Subject: **COLUMBIA GENERATING STATION, DOCKET NO. 50-397  
RESPONSE TO REQUEST FOR ADDITIONAL INFORMATION  
RELATED TO EXIGENT LICENSE AMENDMENT REQUEST FOR  
CHANGE TO TECHNICAL SPECIFICATION 3.8.7 DISTRIBUTION  
SYSTEMS – OPERATING**

## **RESPONSE TO REQUEST FOR ADDITIONAL INFORMATION**

### **NRC RAI No. 6:**

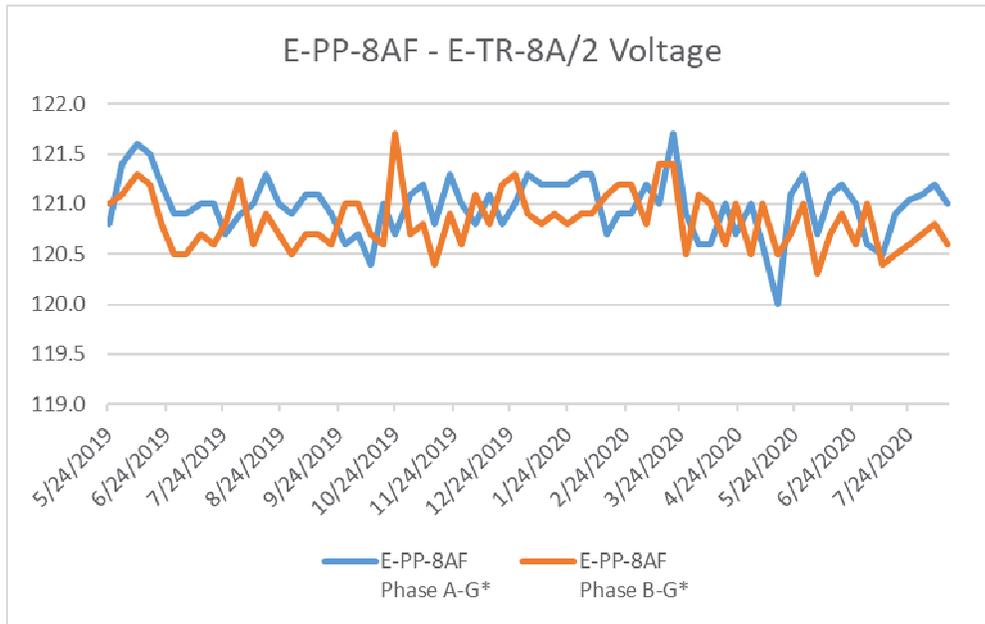
Based on review of responses to RAI No. 2 and 5, in order to provide confidence that the following three voltage regulating type distribution transformers (which are also nearing their end of life - approximate 10 years from the date of last installation) would not fail/degrade during the requested allowed outage time (AOT) extension, please provide voltage plots for the following power panels (similar to voltage plots for panels E-PP-8AE, E-PP-7AE provided in response to RAI No. 5 Question 1).

E-PP-8AF (E-TR-8A/2)

TS Bases 3.8.7 AC Distribution Systems Operating notes that OPERABLE AC electrical power distribution subsystems require the associated buses to be energized to their proper voltages. The figure below plots data obtained from weekly voltage surveillance under TS Surveillance Requirement (SR) 3.8.7.1 for E-PP-8AF.

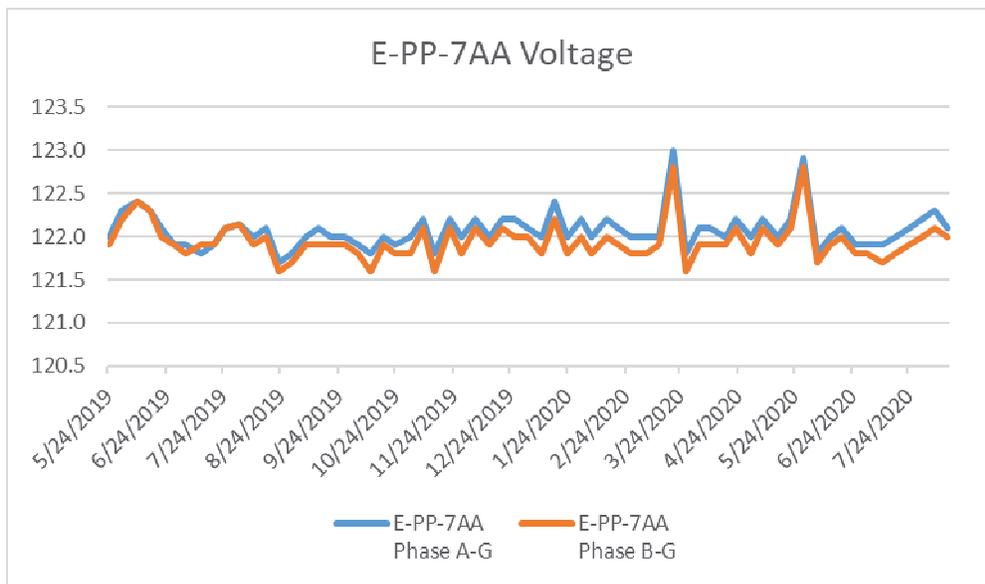
E-PP-7AA (E-TR-IN/3)

Weekly voltage surveillance under TS SR 3.8.7.1 is done by the station for the power panels E-PP-7AA and E-PP-8AA. These readings represent inverter supplied voltage and not E-TR-IN/2 or E-TR-IN/3 supplied voltage. However, the static switch monitors the voltage from these transformers and provides an alarm. This alarm goes to the in-service inverter for “Alternate Source Undervoltage” light on the front of each inverter and provides a main control room trouble alarm input either “IN-2A/2B Trouble,” or “IN-3A/3B Trouble.” The alarm is set at 216 volts alternating current (VAC) which would indicate that E-TR-IN/2 or E-TR-IN/3 have a degraded output. The main control room trouble alarm prompts Operations to respond according to their alarm procedure for each inverter.

A condition report search was performed for the past two years which shows that these alarms have come in three times for “IN-3A/3B Trouble.” Although the alarm came in three times from the “Alternate Source Undervoltage” input alarm for E-IN-3A/3B, they were due to a switching transient and not due to a degraded transformer output.

Similarly, a condition report search was performed for the past two years which shows that the alarm has come in once for “IN-2A/2B Trouble.” This alarm was due to a grid

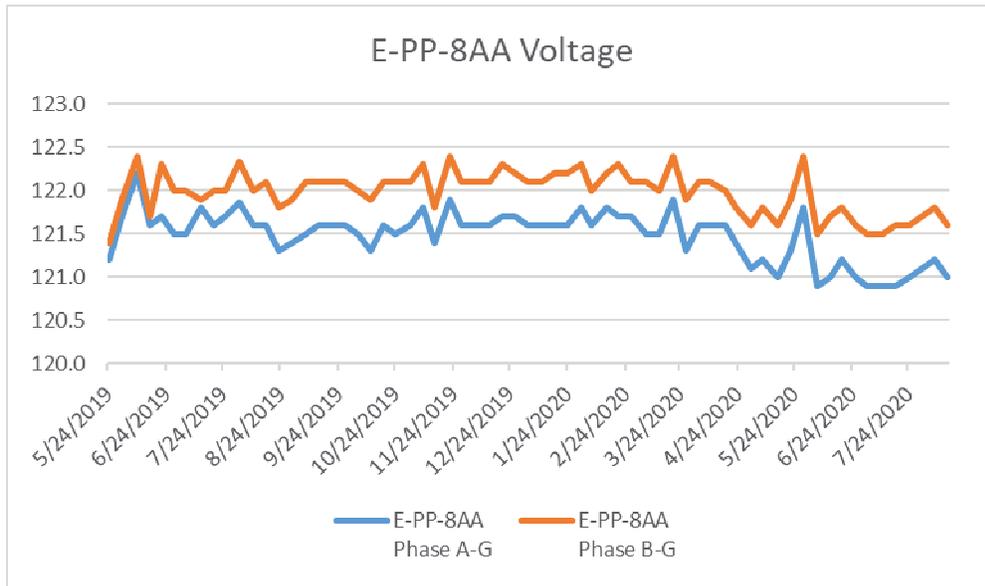
E-PP-8AA (E-TR-IN/2)

The voltages that are shown on the following graphs for E-PP-7AA and E-PP-8AA are voltages that are taken with the inverter supplying the vital instrument busses which is the normal and preferred lineup.

Based on available data and the fact that these transformers are "current" per station PM strategy, there is no evidence to suggest these transformers would fail during the planned replacement of E-TR-8A/1.
